The following change(s) to the tender documents are effective immediately, and will form part of the contract documents:

End of Addendum No.4.

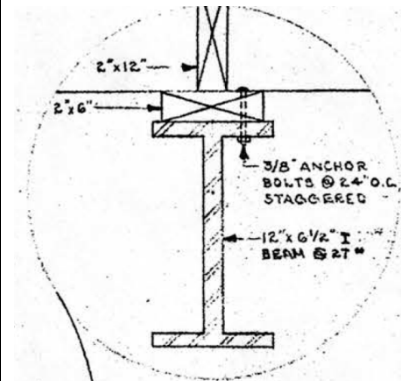
5.1	<p><b><u>Comment</u></b></p> <p>As per our discussion for section 078123 Intumescent Paint, I will need a structural drawing for the beams and columns that require Intumescent Paint. I will need to know the steel sizes to price this project.</p> <p><b><u>Response</u></b></p> <ol style="list-style-type: none"><li>1. According to existing drawings the sizes of the existing columns and beams are as noted below.</li><li>2. Existing Steel columns are 125mm (5") diameter, 3048mm (10'-0") tall</li><li>3. Existing Steel I-Beams are 305mm x 165mm (12"x6 1/2") I beams, 15189mm (50'-0") long</li><li>4. Detail of beam size from existing below is as per sketch below:</li></ol>
